COUNCIL AGENDA REPORT

AGENDA DATE: October 19, 2010

SUBJECT: Appeal Of Architectural Board Of Review Approval Of 903 West Mission Street

PROPOSED WEST ELEVATION 3
 SCALE 1/8" = 1'-0"

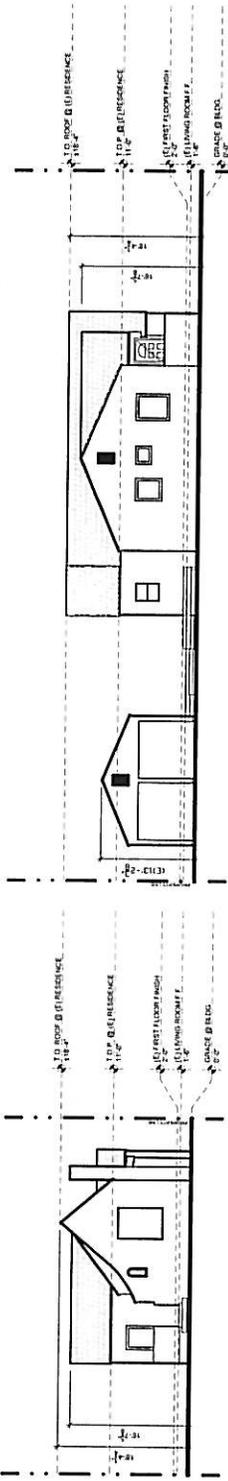
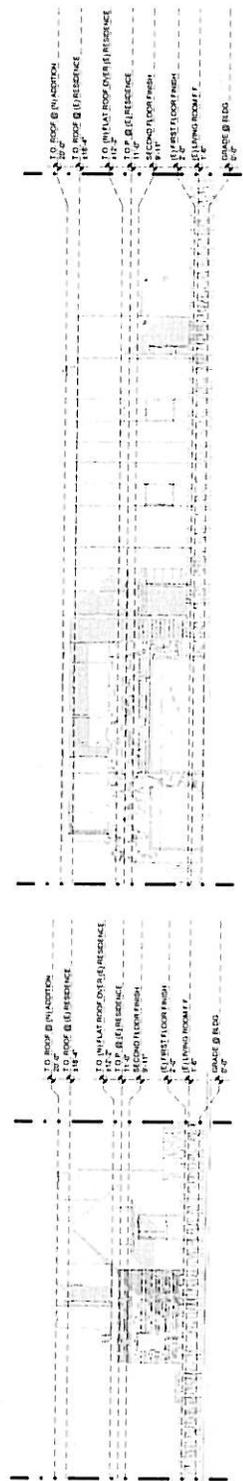
4) The Board looks forward to refinement of the garage elevation to include secondary architectural elements to add additional scale at the garage doors and the lower wing of the west elevation.

KITCHEN ELEVATION 1
1/2" = 1'-0"

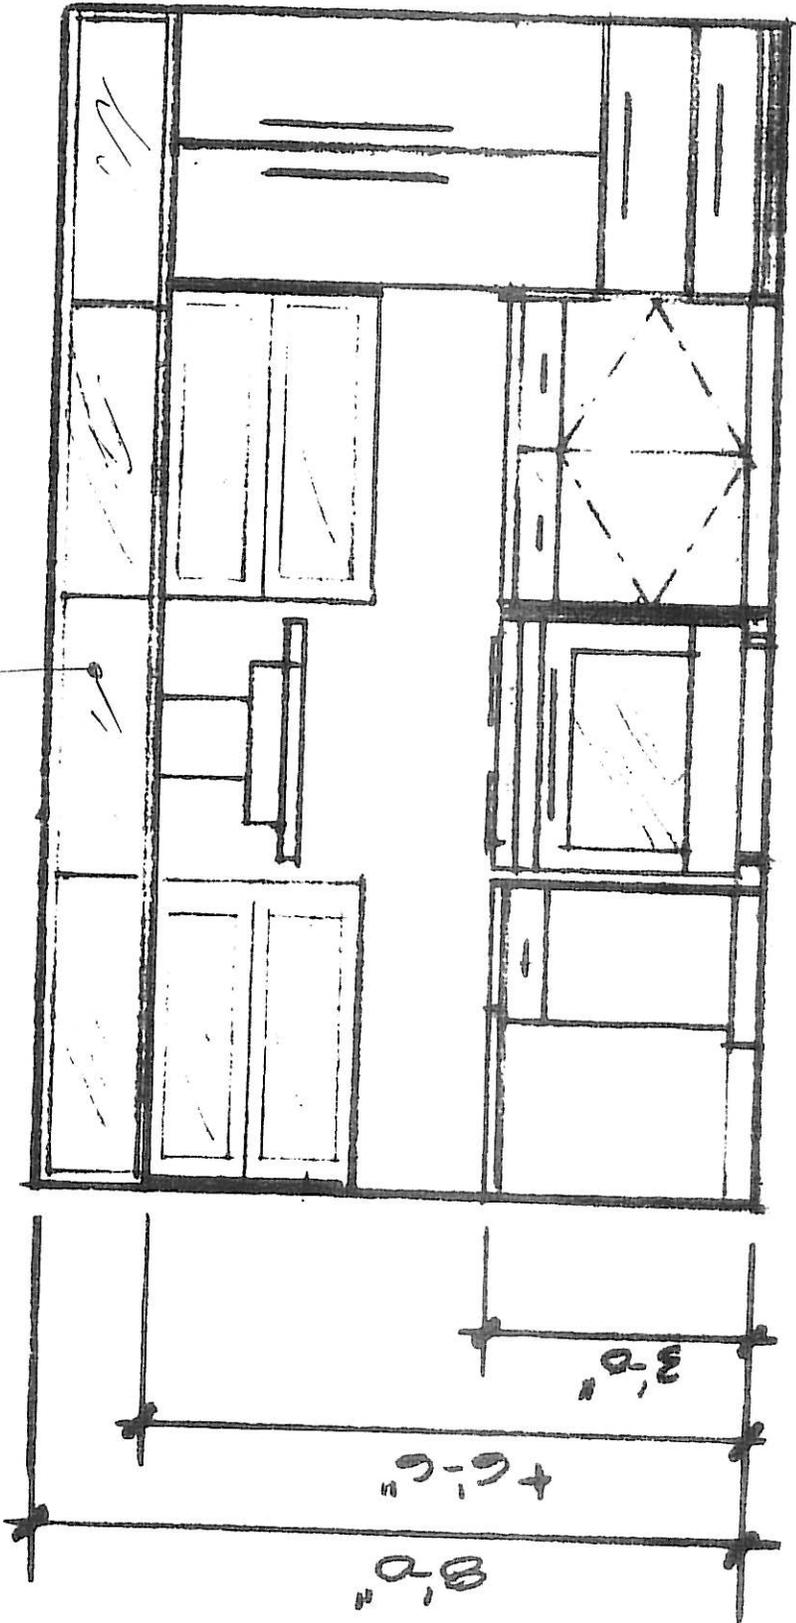
The appellant states that the approved project negatively affects her property values, because allowing a window on the second story facing west, will encroach upon her privacy.

The applicant proposes a clerestory window that is 7'-6" above the finished floor of the second story (Attachment 5). The ABR stated at the last meeting that the applicant's privacy concerns had been adequately addressed. Staff believes that the clerestory window does not result in a privacy issue.

The proposed clerestory windows are compatible with the proposed modern architectural style; however, if the project were to be revised to a more traditional style, it could result in windows that may actually impact the appellant's privacy.

Perspicitve From Backyard of Adjacent Property
Existing home and 2 car garage

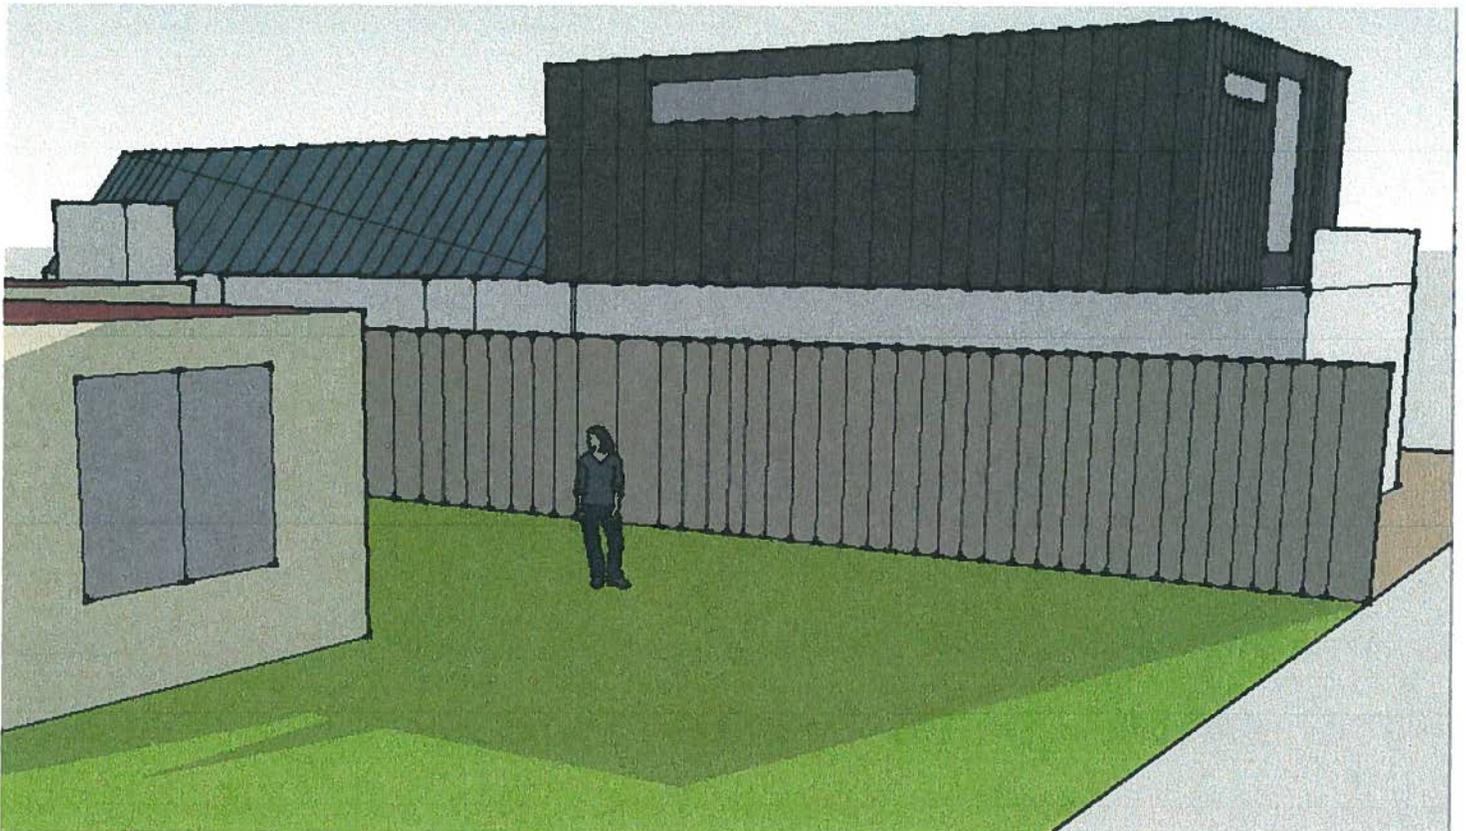
the requirement to add a 3 car garage and therefore the entire building would be less imposing and massive than building a second story over a new 3 car garage which blocks the air space, sun, and mountain views from my backyard. A second story added over the existing house would also be less invasive of my property's backyard privacy.

Proposed all-in-one structure: main house, accessory dwelling unit, and new 3 car garage

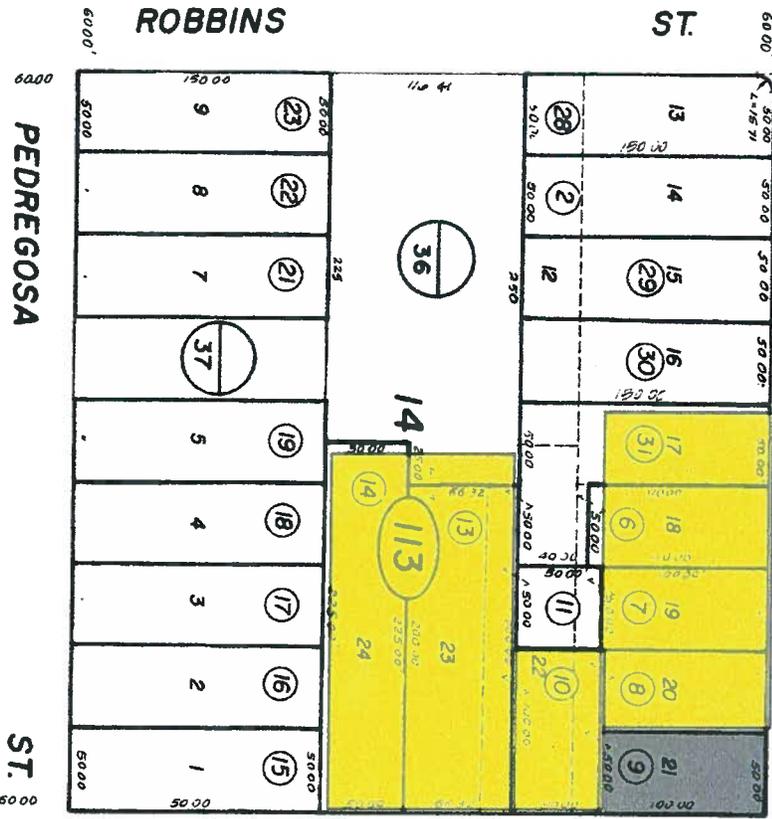
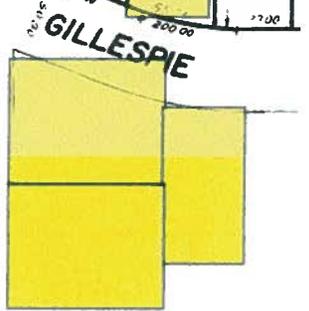
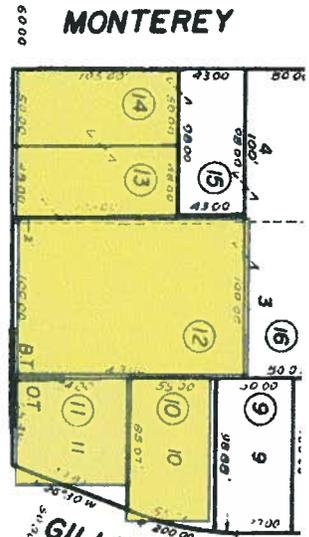
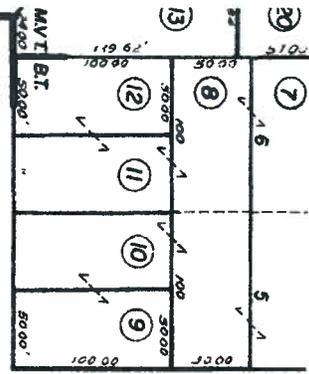
1) **The design plans that were approved are not compatible with the neighborhood in mass, bulk, or architectural style.** The proposed plans are for a very modern architectural style with metal siding, which is not compatible with our neighborhood. The Westside is one of the oldest neighborhoods in Santa Barbara. This industrial looking modern architecture and the large mass of this structure steal the heritage and charm of our neighborhood.
